April 12, 2018

**RE: RESPONSE TO EPA COMMENTS DATED MARCH 21, 2018  
ON JULY 2017 GROUNDWATER SAMPLING REPORT  
PFIZER PHARMACEUTICALS LLC, BARCELONETA SITE, EPA ID PRD090346909**

RE: RESPONSE TO EPA COMMENTS ON  
JUNE 2007 DRAFT SUPPLEMENTAL RFI REPORT  
PFIZER PHARMACEUTICALS, LLC  
BARCELONETA, PUERTO RICO SITE  
EPA I.D. NO. PRD-090346909

**MONITORING WELL MW-1  
CHLOROBENZENE IN GROUNDWATER - FEBRUARY 2003 TO JANUARY 2018  
GROUNDWATER MONITORING REPORT - JANUARY 2018**

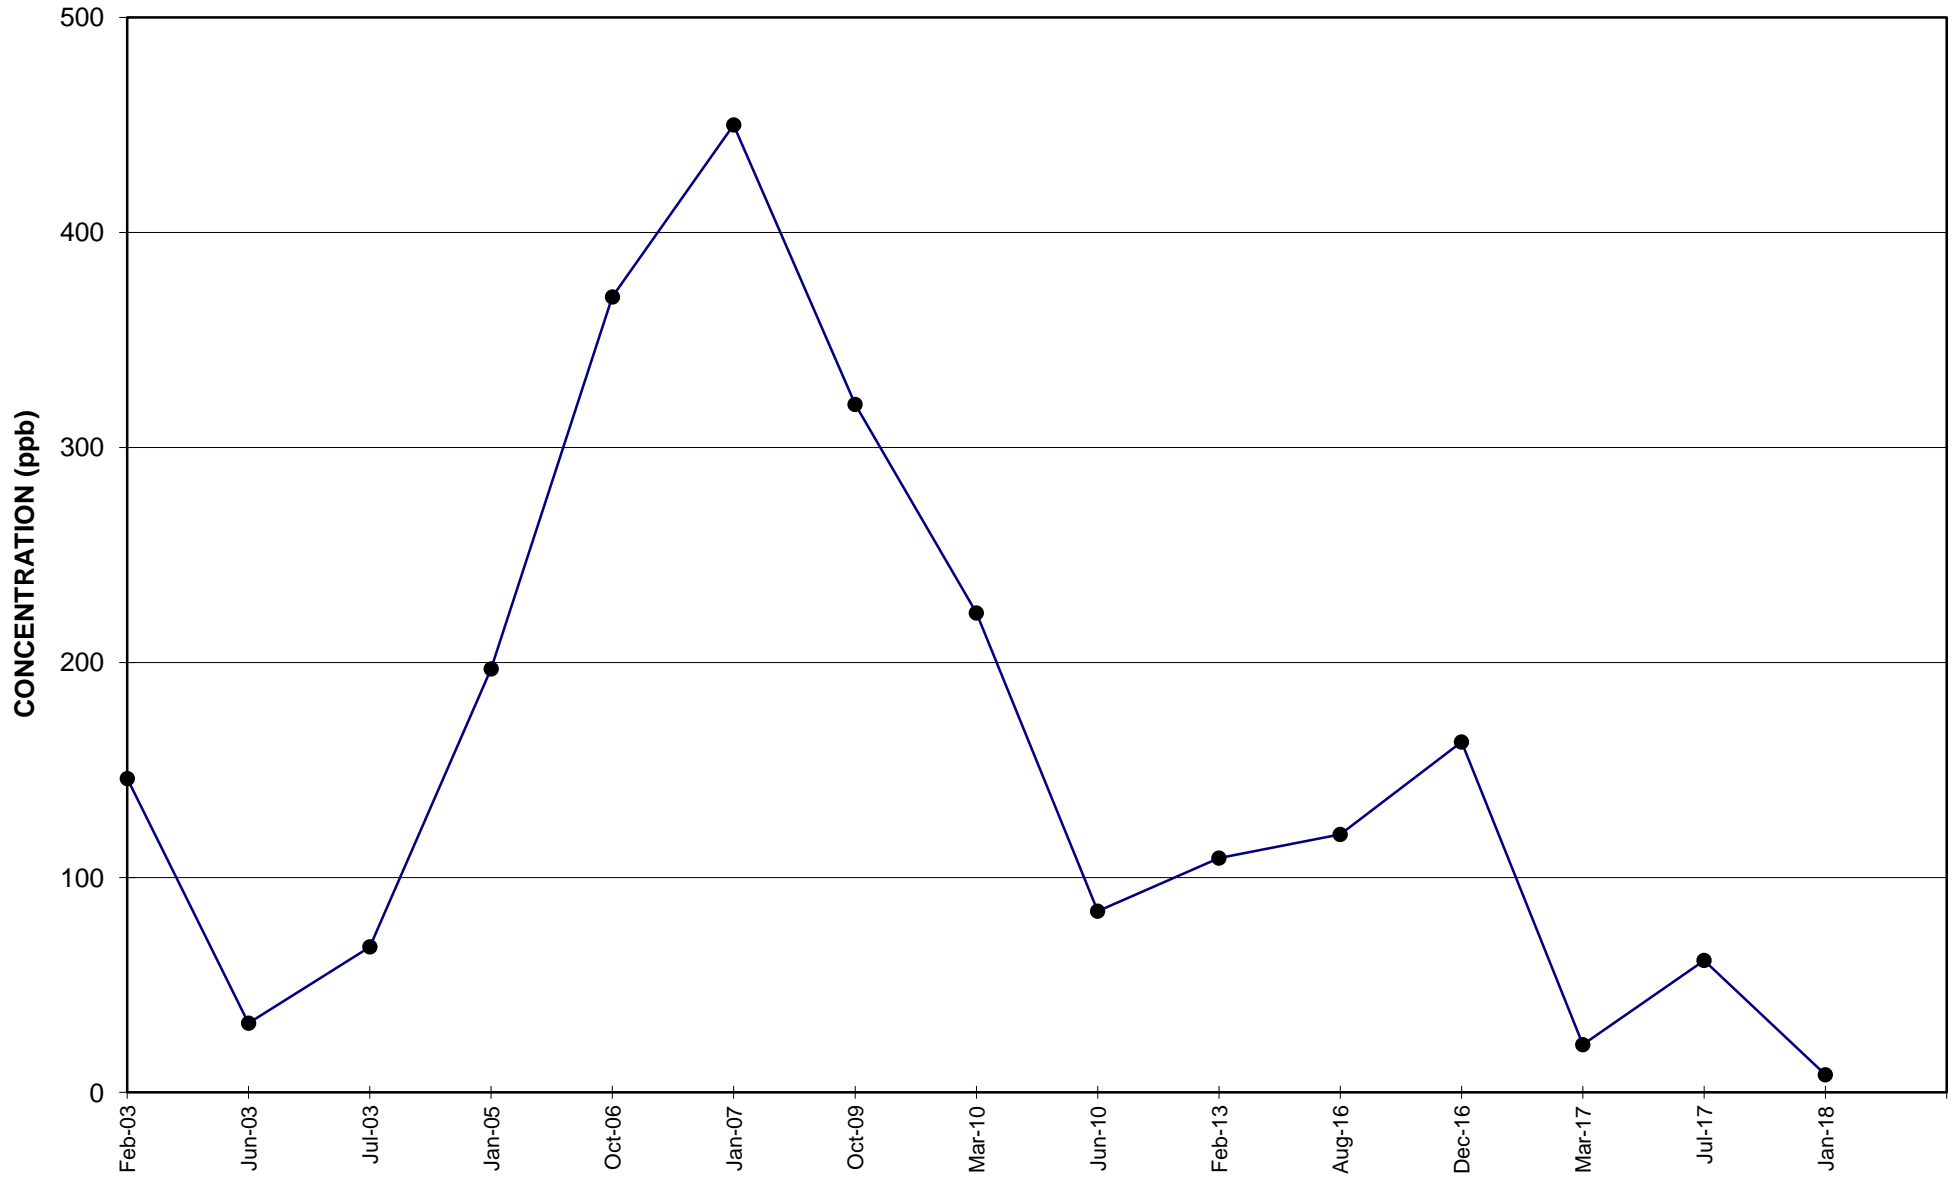
*unclear whether remediation is occurring in that location. It is also noted that chlorobenzene concentrations in MW-1 have increased slightly since March 2017 from 22.2 ppb to 61.4 ppb. The Groundwater Report should discuss the historical trends of chlorobenzene and evaluate whether remediation is effective. This information should be discussed in the recommendations section of the report. Currently the only recommendation in the Report is to modify the sampling frequency to semi-annually.*

The last groundwater sampling event performed during January 2018 indicated that chlorobenzene concentrations decreased from 61.4 ppb (July 2017) to 8.20 ppb (January 2018) in well MW-1, and from 33.7 ppb (July 2017) to 20.4 ppb (January 2018) in well MW-2. January 2018 data for other monitoring wells (MW-5 and MW-6) indicated that chlorobenzene has been consistently non- detect in well MW-5 and continues to decrease in well MW-6 (3.7 ppb in March 2017 to 1.7 ppb in July 2017 to below detection limit in January 2018) indicating source depletion. Updated historical groundwater monitoring data is included in Attachment B.

MONITORING WELL MW-2  
CHLOROBENZENE IN GROUNDWATER - FEBRUARY 2003 TO JANUARY 2018  
GROUNDWATER MONITORING REPORT - JANUARY 2018

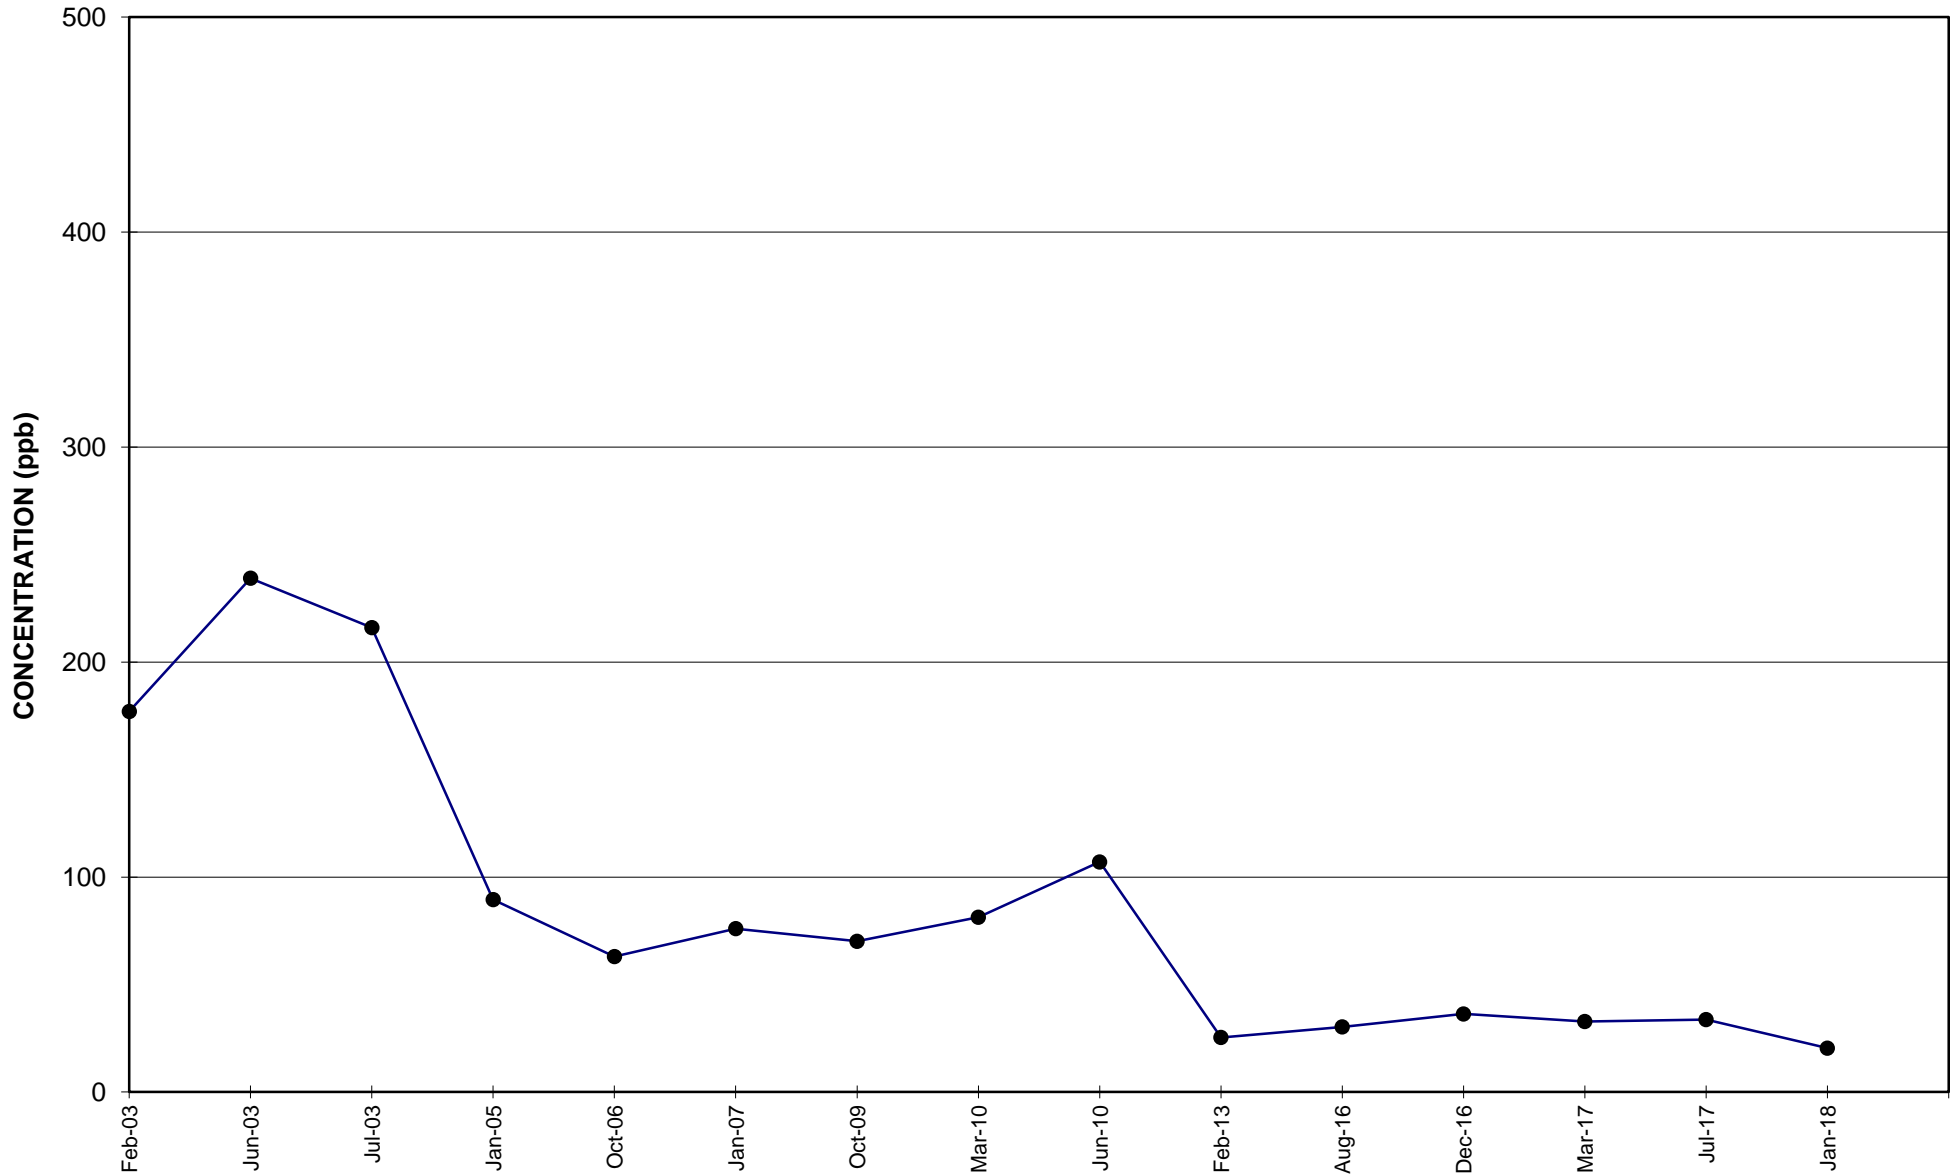
*A second concern noted in the review is that chlorobenzene concentrations within monitoring well MW-2 appear to be fairly constant. Comparison of the data in Appendix 4 indicates that the chlorobenzene concentration in 2013 was 25.5 ppb, and now in 2017 it is 33.7 ppb. As such it is*

The groundwater monitoring data summary report was intended to provide the sampling/analytical data (results), such that additional interpretations (e.g. historic trends) were planned to be included in the Remediation Completion Report – after the SVE system is discontinued based on benzene levels in soil vapor (which was is the main risk driver). Nevertheless, a brief discussion on groundwater trends will be included in future reports. Please refer to our response to Comment #1 regarding the purpose of such groundwater monitoring.
